Date: May 16, 2024
Ref: PEG-1155-93M-CN-HI-BOA-LET-ES-10366

Project: Engineering, Procurement and Construction of the New Administrative Capital Monorail and 6th October City Monorail (Contract 93/Metro).

Subject: Non-conformities in Shop Drawings. // 93M-BOA-NAT-LOT-26031

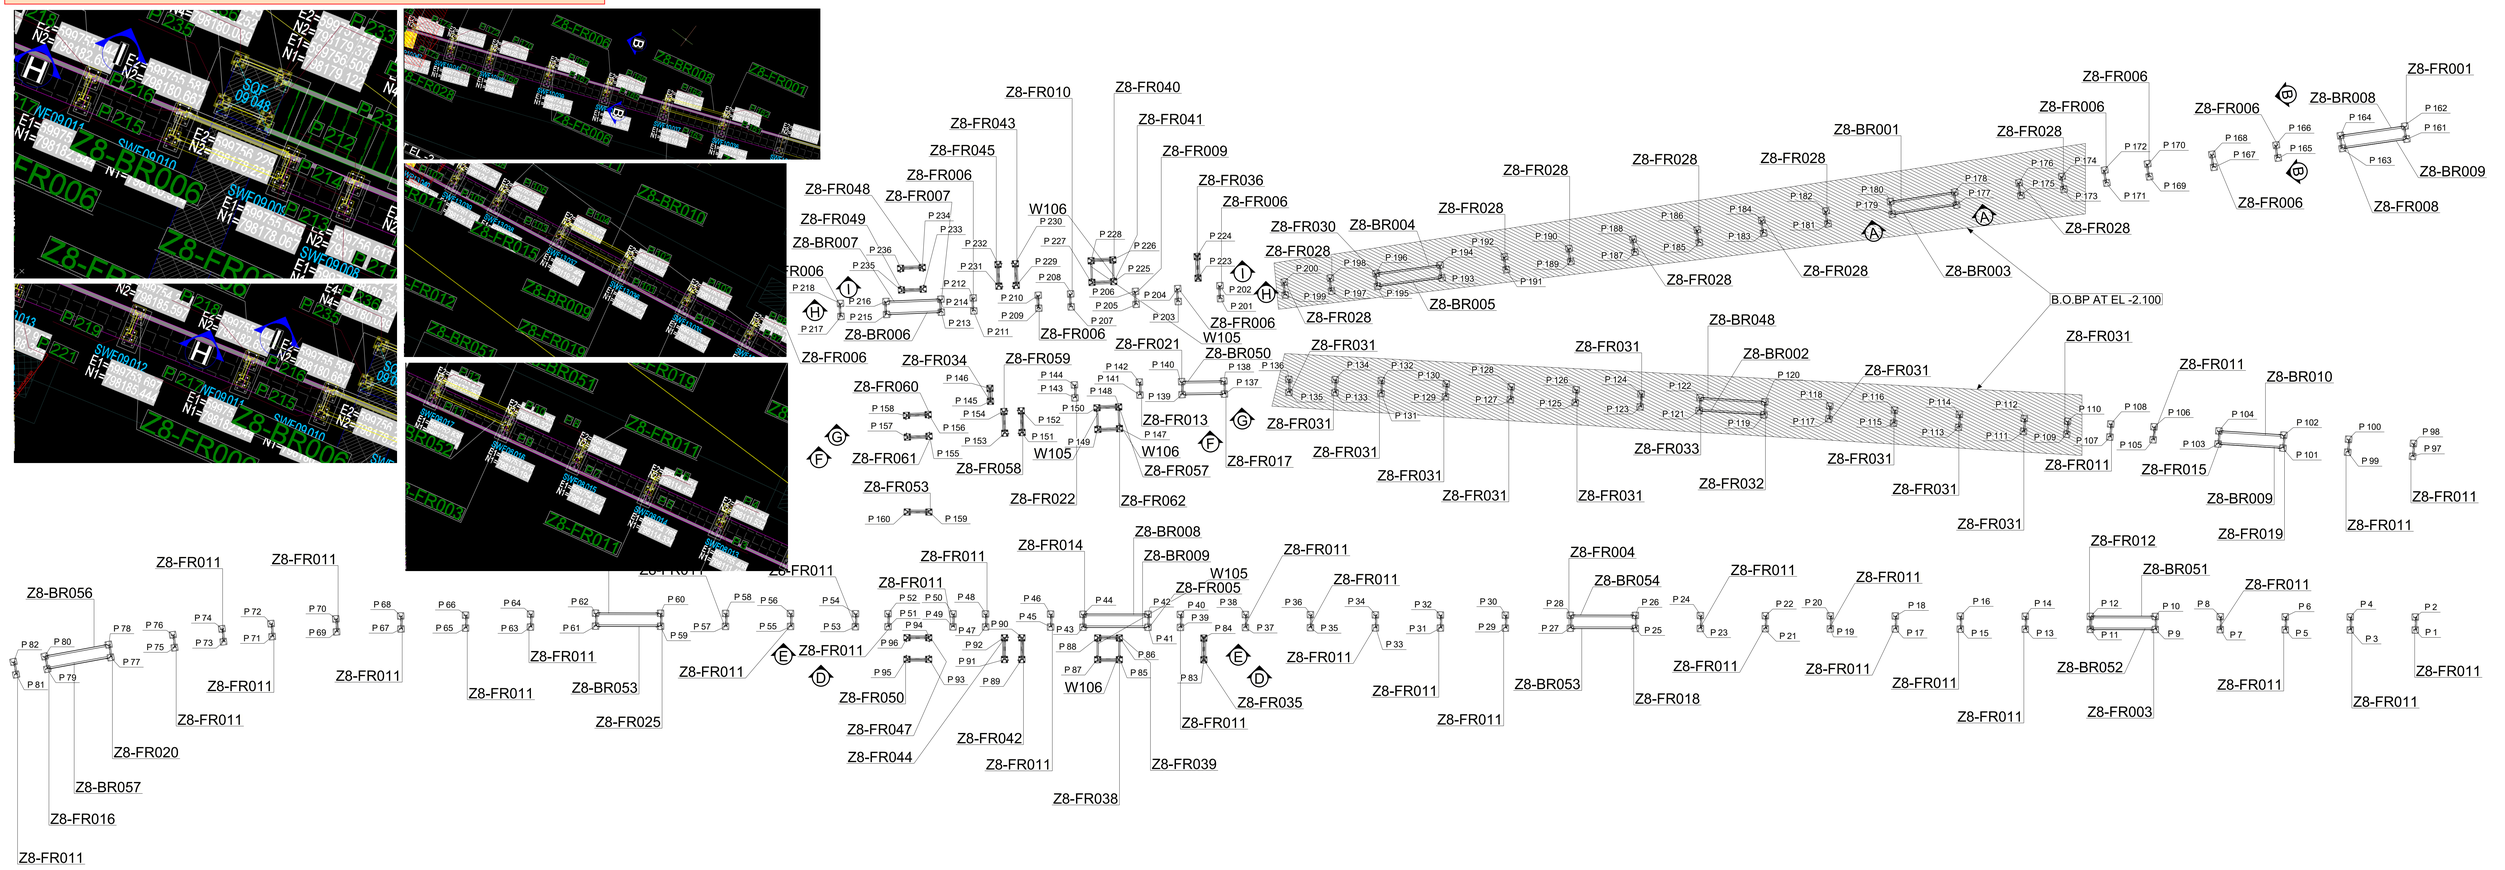
According to drawings no.93M-0476-INN-6ODEP-PAL-10009 to 93M-0476-INN-6ODEP-PAL-10011 for the planning of the foundations of zone01,There is a shift between the planning reference and the shop drawings as shown in the taken snaps below.

DRAWING TITLE
6TH OF OCTOBER MONORAIL
SERVICE WALKWAY
ZONE (1008)
PLAN AT EL+0.350

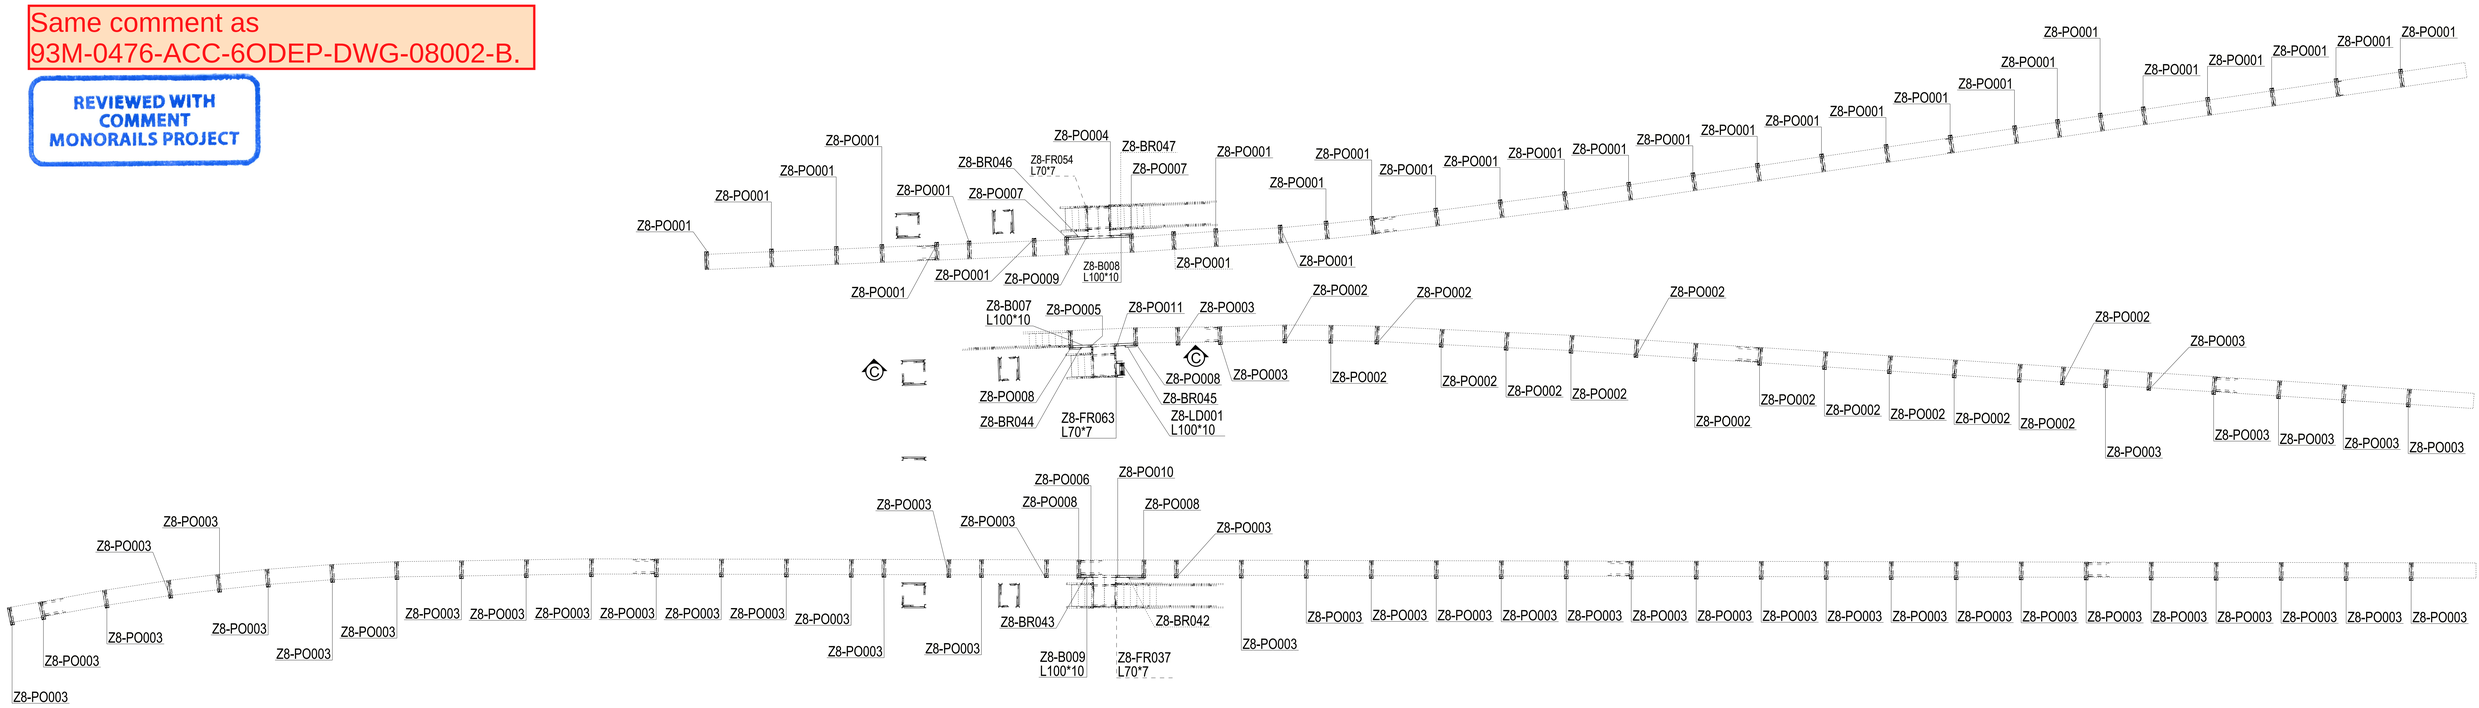
Same comment as
93M-0476-ACC-6ODEP-DWG-08002-B.

DRAWING TITLE
6TH OF OCTOBER MONORAIL
SERVICE WALKWAY
ZONE (1008)
HANDRAIL PLAN

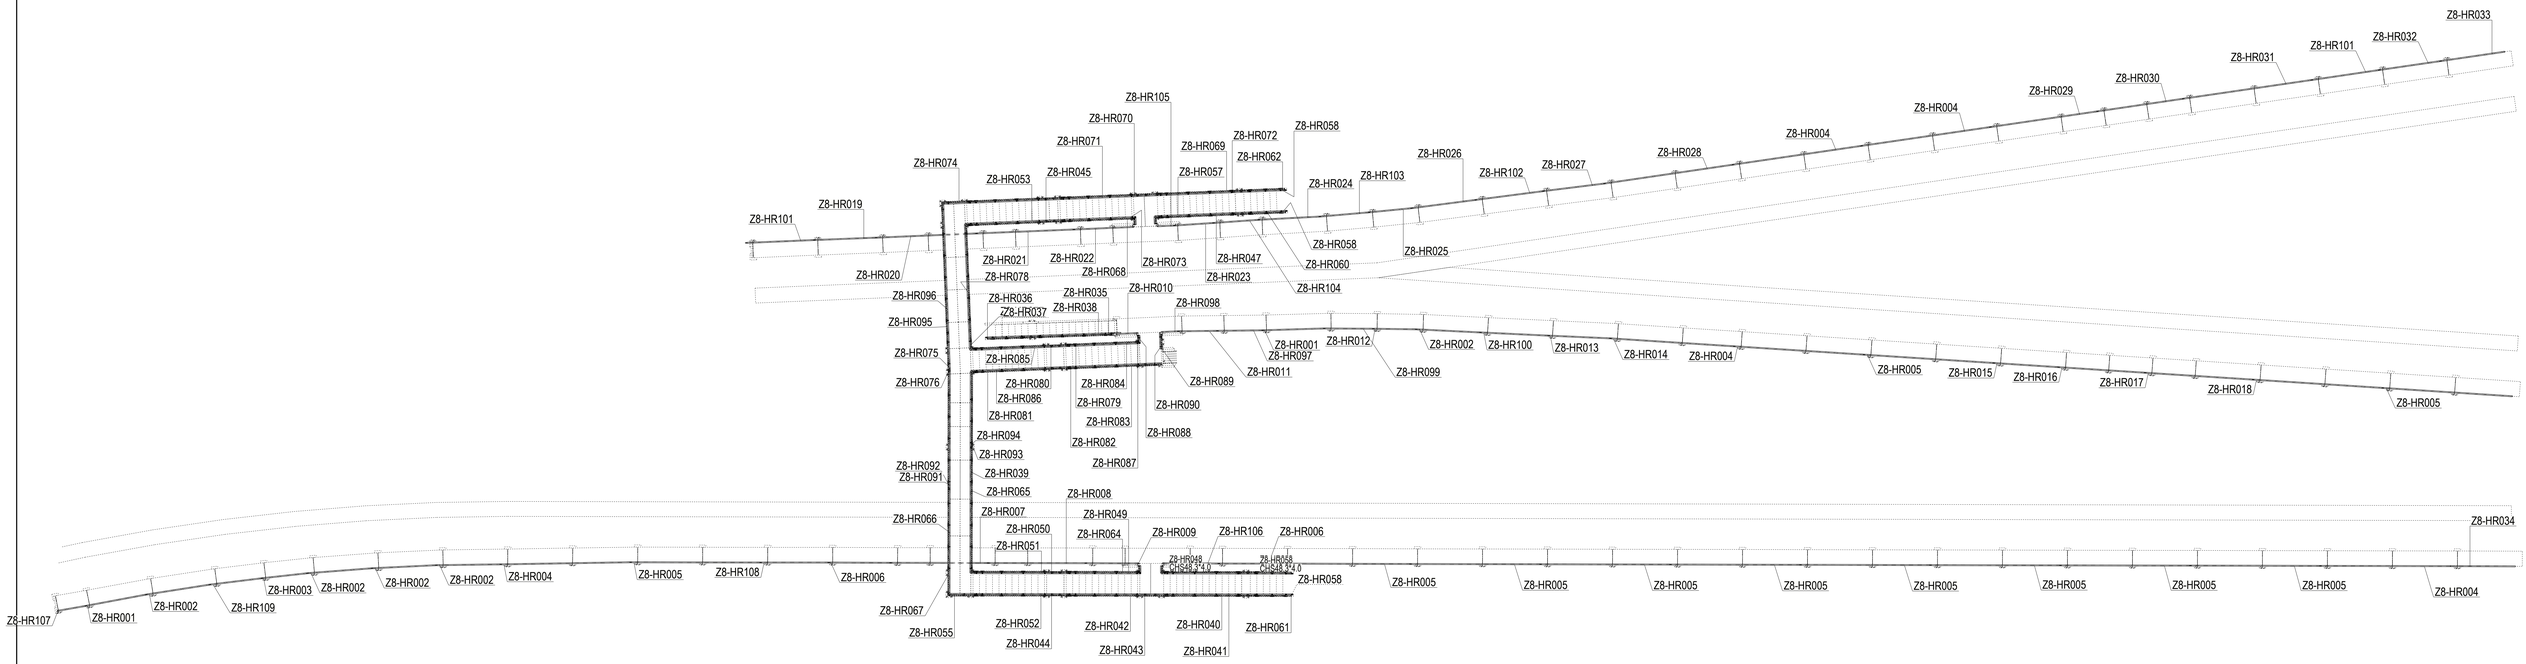
Same comment as
93M-0476-ACC-6ODEP-DWG-08002-B.

6TH OF OCTOBER MONORAIL SERVICE WALKWAY
ZONE (1008)
CHEKERED PLAN

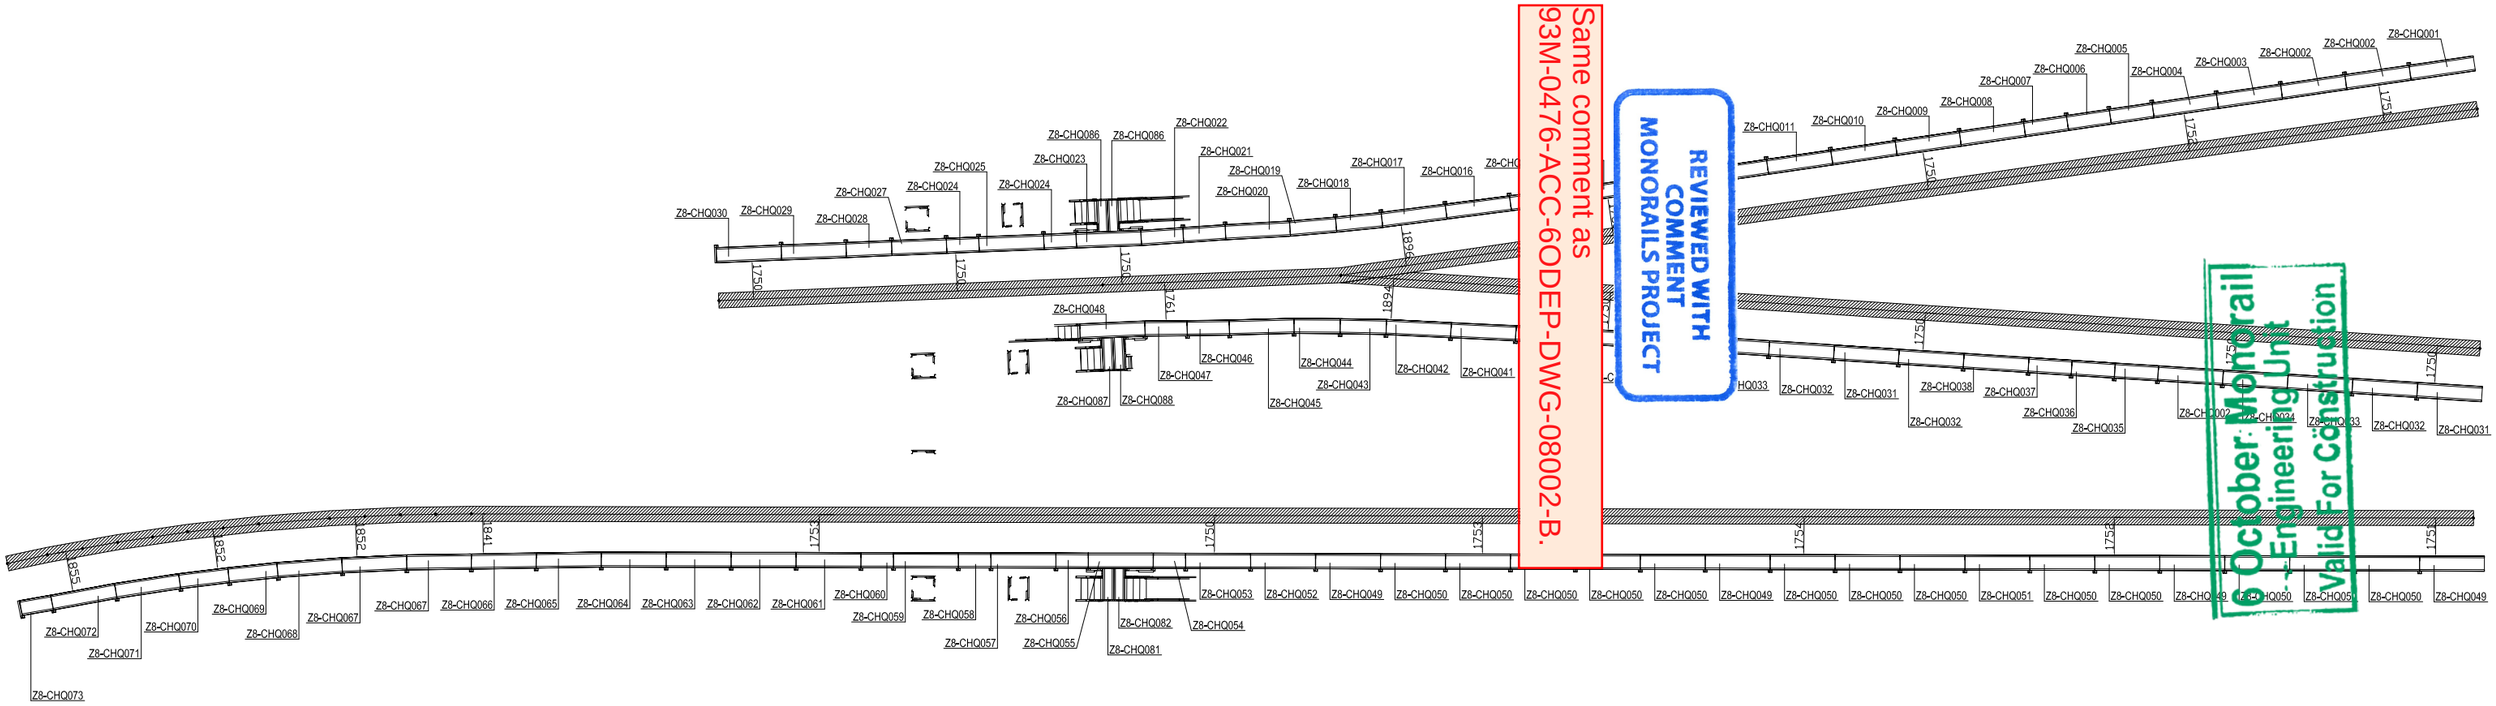
Same comment as 93M-0476-ACC-6ODEP-DWG-08002-B.

SECTION : F - F
SCALE 1:30

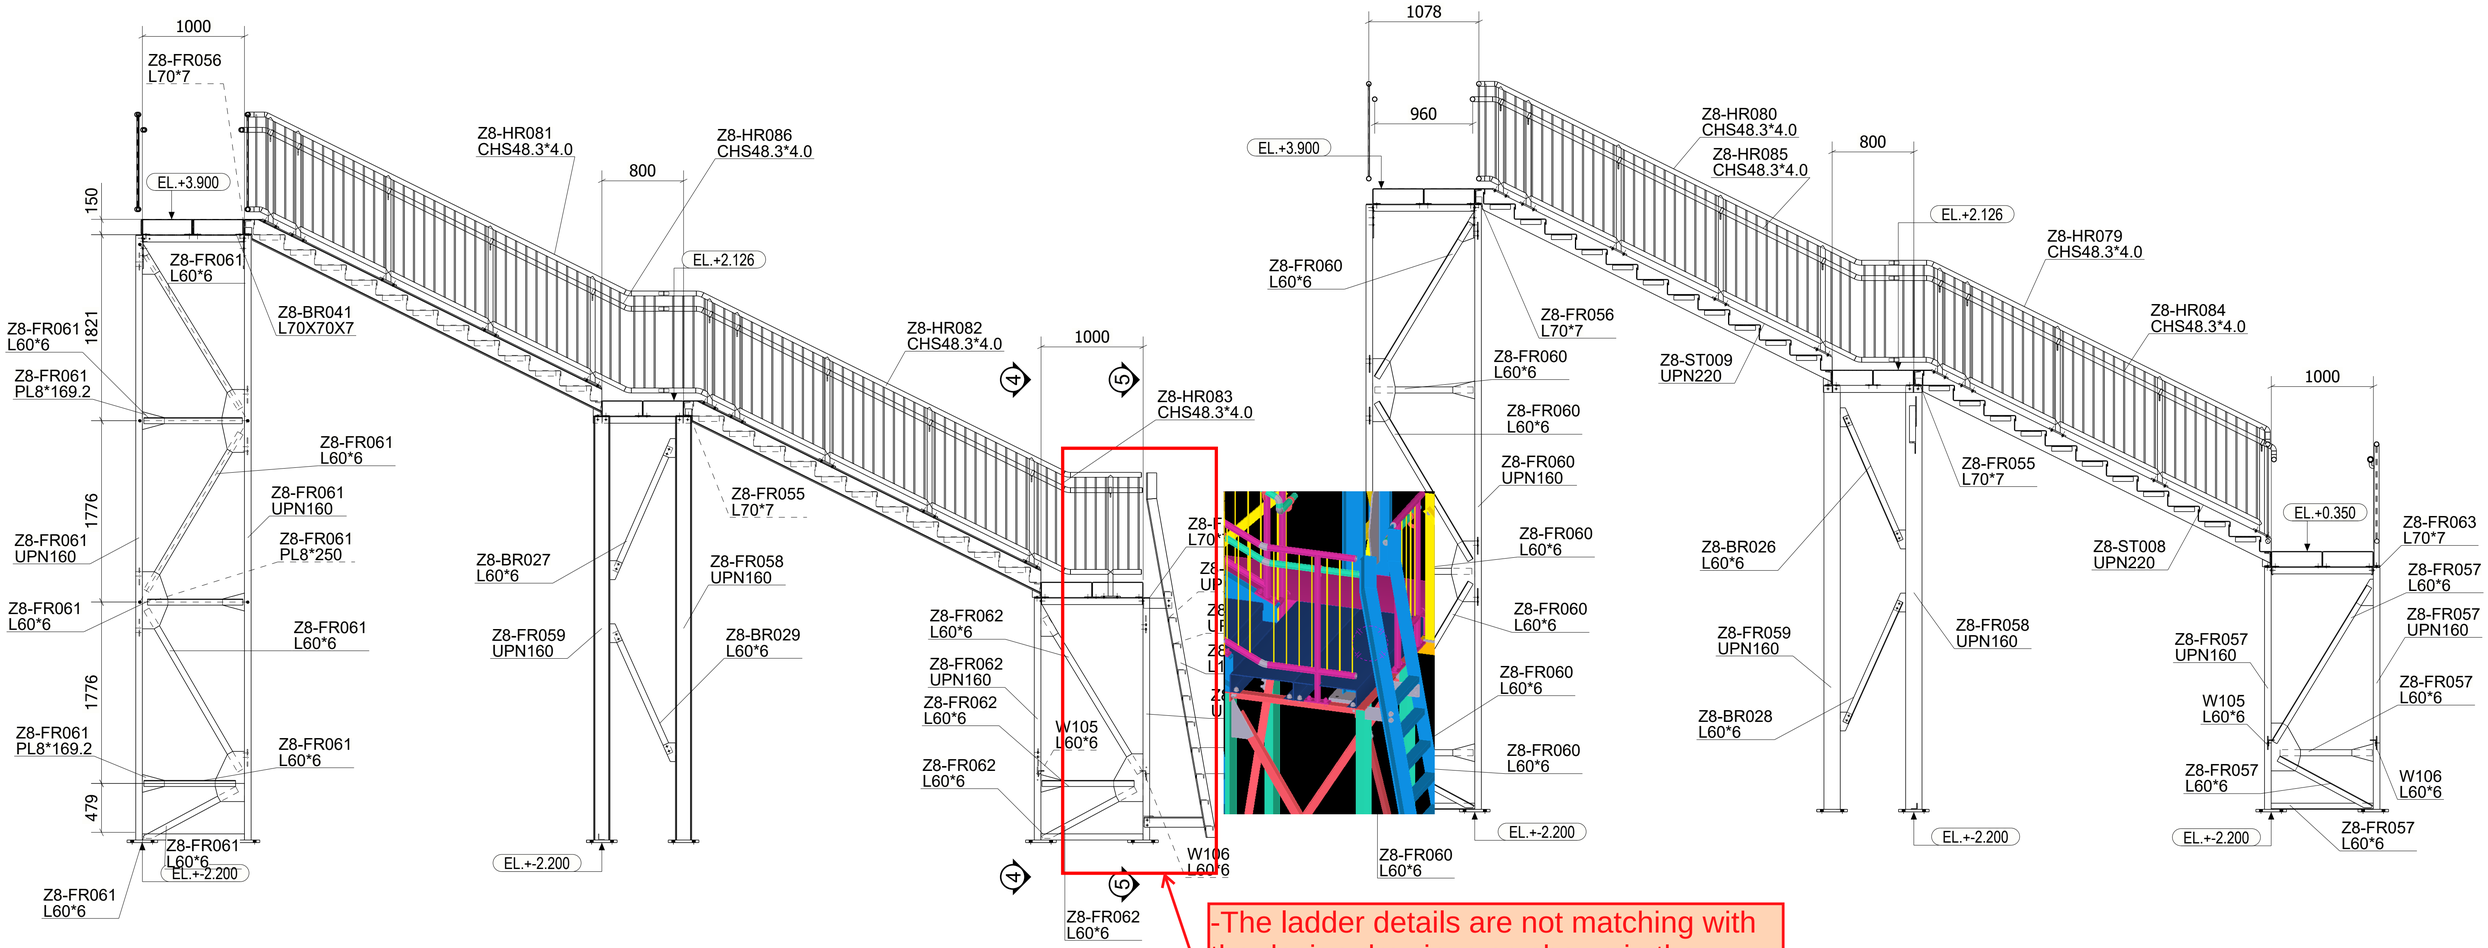
-The ladder details are not matching with the design drawings as shown in the design snap and IFC model snap.

1 *REQUIRED AS DRAWN MARKED* **Z8-B003**

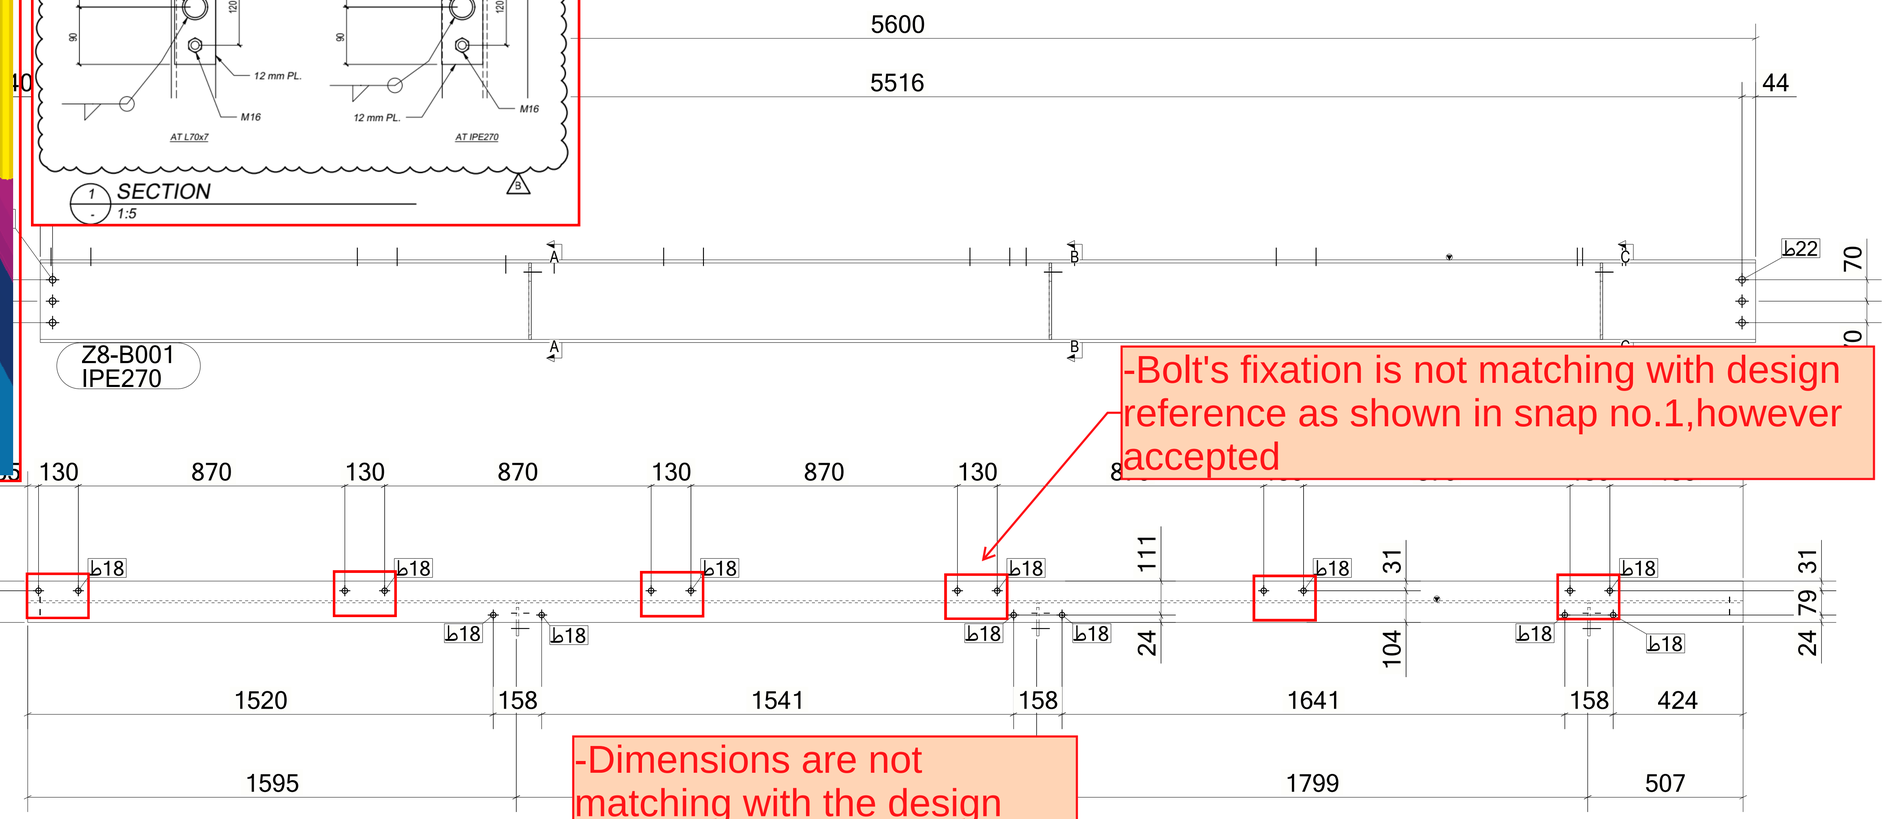
-Bolt's fixation is not matching with design reference as shown in snap no.1,however accepted

-Dimensions are not matching with the design drawings as shown below ,however accepted
